Date this letter: 09th January 2023

Planning Ref: SD22A/0320/Order: 1207

RE: FURTHER INFORMATION REQUEST ON PLANNING APPLICATION NO. SD22A/0320

"Rathinree", Esker Lane, Lucan, Co. Dublin K78 X2C4

No. 26 & 27 Esker Pines: photograph (above left) and extract from 2001 planning site plan (above)

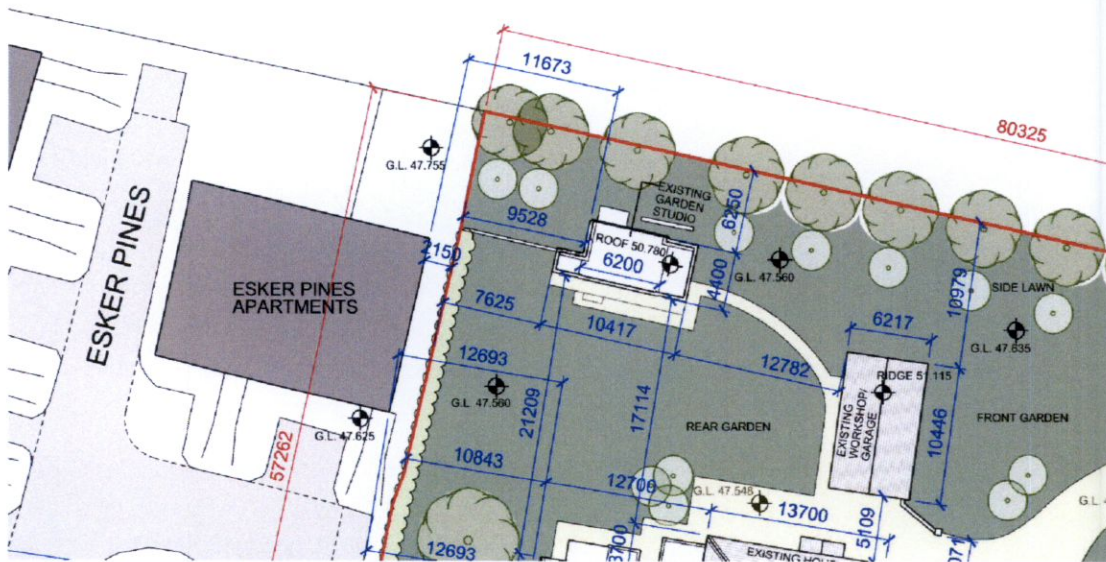
1. The Applicant is requested to increase the setback distance from the adjacent western boundary, providing appropriate separation distances to adjacent properties (having regard to concern about overbearing effects) and the existing dwelling on the subject site. The Applicant is requested to provide a complete set of revised site layout, floor plan, sectional, elevational and contiguous elevational drawings demonstrating the revised location and design of the proposed dwelling.

1A: Clarifications: The adjacent property 26 & 27 Esker Pines, is in ownership of the applicant.

- The unit is part of a mixed-residential development, duplex-over-ground level apartments distributed over three storey blocks that come to an abrupt gable end 2.15m off the applicant's boundary wall. The very close proximity is slightly mitigated by hedgerow on Esker Pines side (see left), and additional hedgerow on the applicant's site.

PROPOSED GROUND FLOOR PLAN
Scale 1:100

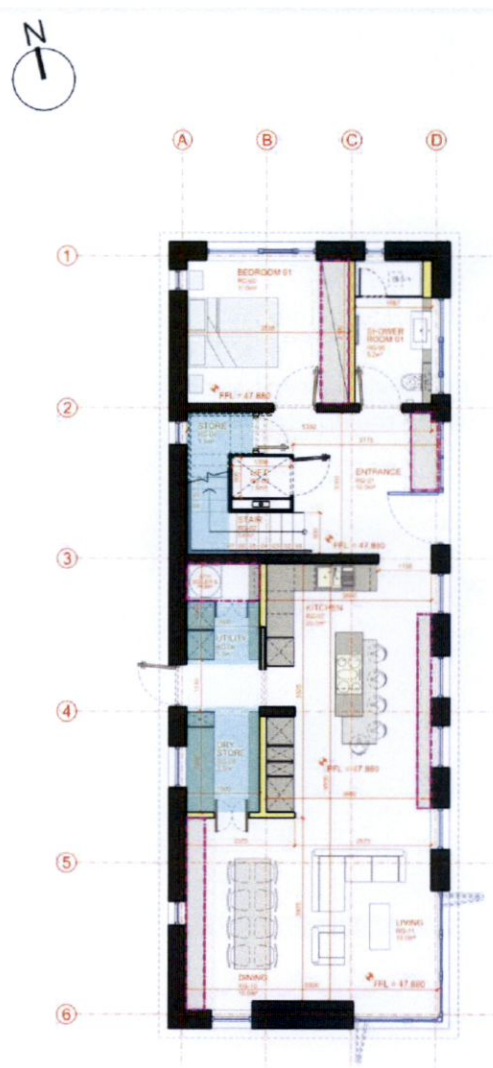
3. The Applicant is requested to provide revised drawings demonstrating compliance with the internal storage space standards outlined in Section 12.6.7 of the South Dublin County Development Plan 2022-2028.

The floor plan overleaf shows the area breakdown and that the achievement will be substantially greater than those storage requirements set out in the guidance documents.

The assigned storage excludes extensive but thoughtfully considered fitted/ loose fittings e.g. wardrobes, cloaks/ coat/ boot rooms/stores, library, shelving and joinery/ cabinetry items. These will be substantial extensions to the storage figures achieved in the drawings as dedicated spaces for planning purposes.
